MEMORANDUM

SUBJECT: Port Wallace Master Plan – Highway 107 Overpass

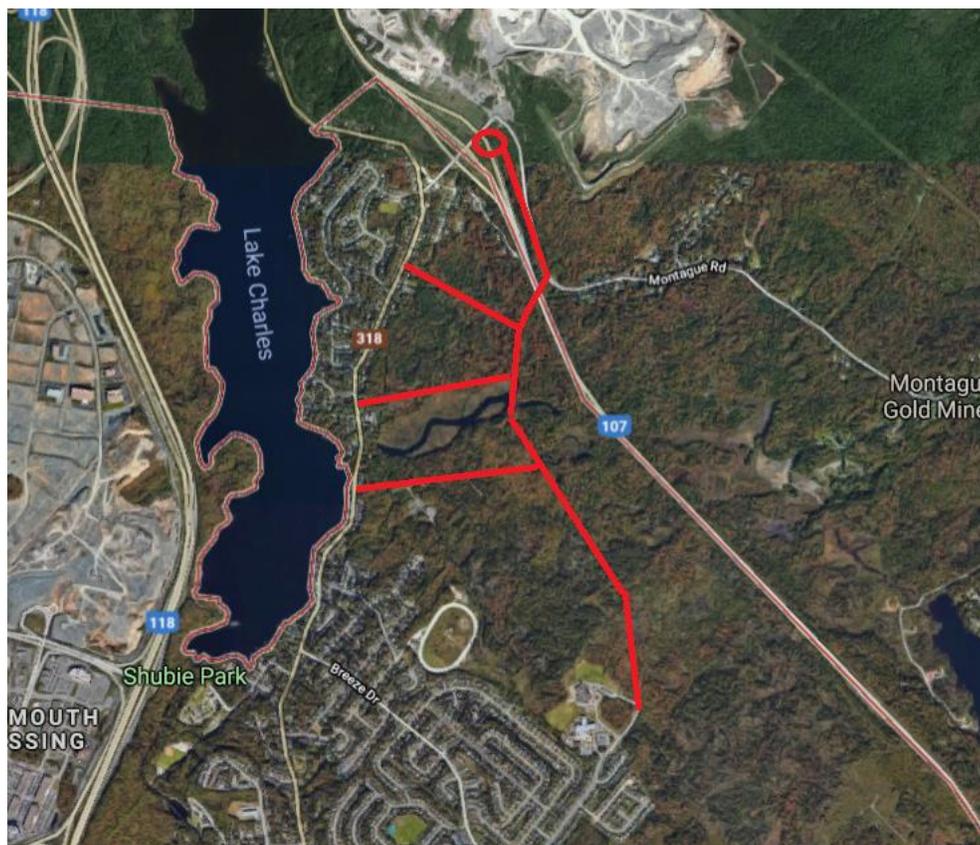
In response to the Public Participation Committee's request, I have examined the feasibility of connecting the internal loop road to Montague Road on the other side of Highway 107. The rationale for the request is that it would give motorists another option to access Highway 107 and potentially bypass a section of Waverley Road. I have used the following concept sketch provided by Adam Flick as a starting point:

I have assumed from Mr. Flick's sketch that there would be still three local street connections to Waverley Road, and that the internal collector road would connect to Montague Road which would Tee into the new collector road. I have assumed that the road network would look something like this:

Figure 1 Approximate Crossing Point

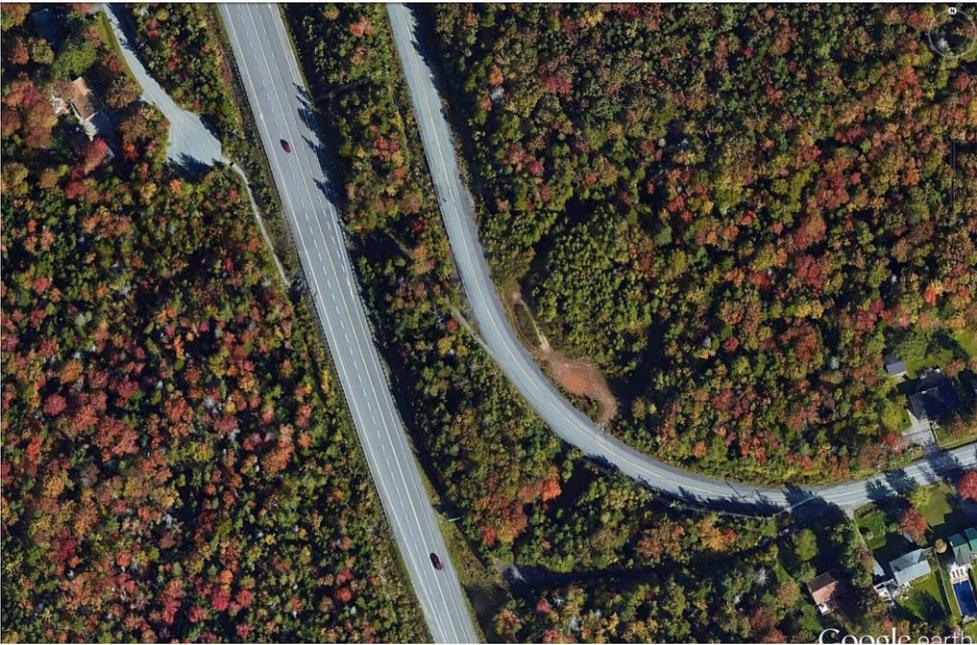
The challenge with crossing Highway 107 at this location is the angle of crossing and the proximity to the Montague Road interchange. The proposed bridge would cross Highway 107 at an approximate 40-degree angle which would increase the span length. The on and off ramps to the Montague Road interchange would also need to be accommodated making the total span of roughly 60 metres.

Grades are also a challenge. To cross over Highway 107 would require an approach grade that exceeds 12%. The maximum grade for a minor collector road is 8%.

The cost of the bridge would be roughly \$5 - \$10 million. This does not include the re-grading and realignment of Montague Road would be another \$7 - \$10 million, making the total cost of the project \$12-\$20 million.

Given the grades and the cost, the option of connecting the internal loop road to Montague Road to the other side of Highway 107 is not feasible.
